ADDENDUM NO .1 Competitive Solicitation Number ITB5348-1

TITLE: Furnish and Install Custom Lectern & Equipment

APPS Conference Center Presentation Technology Project

Addendum #1

● Lectern Placement

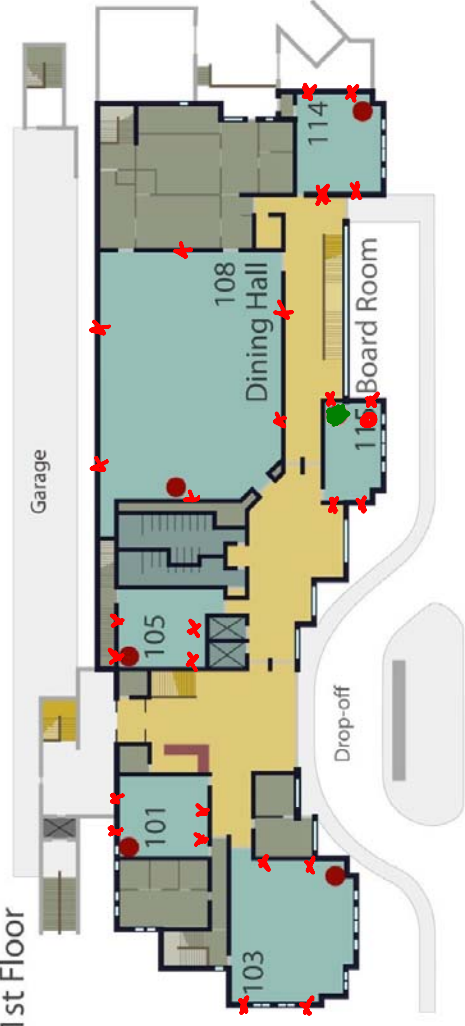
4. Mark general location of speakers in rooms –See attached drawing. The red "x" marks the location of the speakers.
